IEEE 802.11
Wireless Access Method and Physical Layer Specifications

Protocol Layering Alternatives for Practical Implementation

September 15, 1993

Figure 1. Reference Model Alternatives

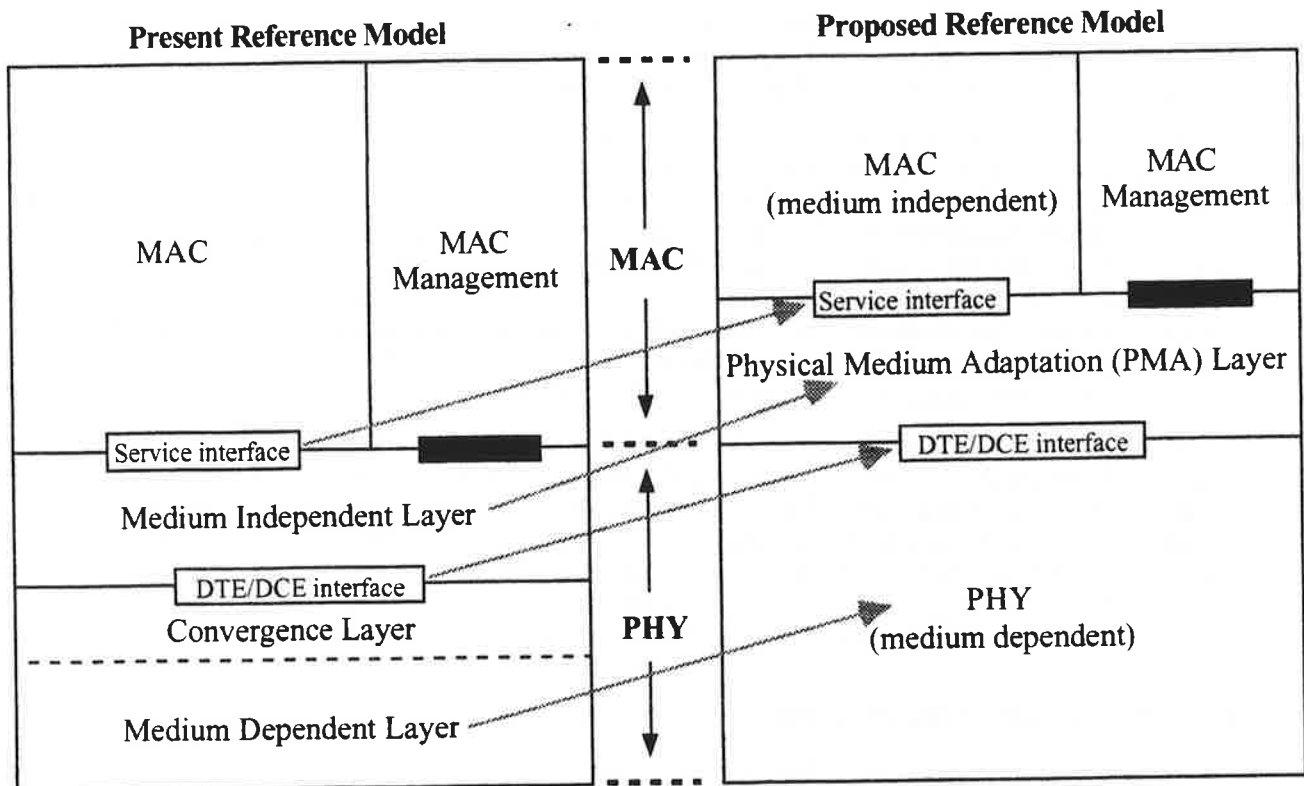
This change, which is illustrated in Figure 1, involves more re-labeling than functional change:

- The name “Medium Independent Layer” is shown as changing to “Physical Medium Adaptation (PMA) Layer.” Since the relative position of this layer, between the service interface at the bottom of “MAC” and the DTE/DCE interface at the top of “Physical Medium Dependent,” has not changed, the name could be left unchanged as well. However, the MAC is, by definition, medium independent, so the equivalent construct to “medium independent PHY” is “medium dependent MAC.” The name change to “Physical Medium Adaptation” is proposed to avoid confusion with the pre-existing labeling, and to more accurately reflect this layer’s functional role, which is adaptation between an abstract service interface and a concrete modem interface.

- The “Convergence Layer” is shown as being eliminated. Because the interface between the “Convergence Layer” and the “Medium Dependent Layer” was not an exposed interface, the sole purpose of making a distinction between these two layers is to permit an 802.11-compliant DTE/DCE interface to be added to a pre-existing wireless modem. With the “Medium Independent Layer” removed from PHY, the DTE/DCE interface becomes the MAC-PHY interface, which is inherently exposed. This appears to render the “Convergence Layer” unnecessary.
- The PHY is no longer subdivided, so the name “Medium Dependent Layer” can be dropped, and the physical layer can be referred to simply as “PHY.”
- The MAC is now subdivided laterally, in addition to longitudinally for “MAC Management.” Since the functions above the MAC service interface are unaffected by this change, there is no reason to re-label “MAC.”

NO. There should be a medium-dependent subdivision added to MAC (suggested name is "Physical Medium Adaptation Layer"), and the subdivision on PHY should be eliminated. This is discussed in further detail in this document.
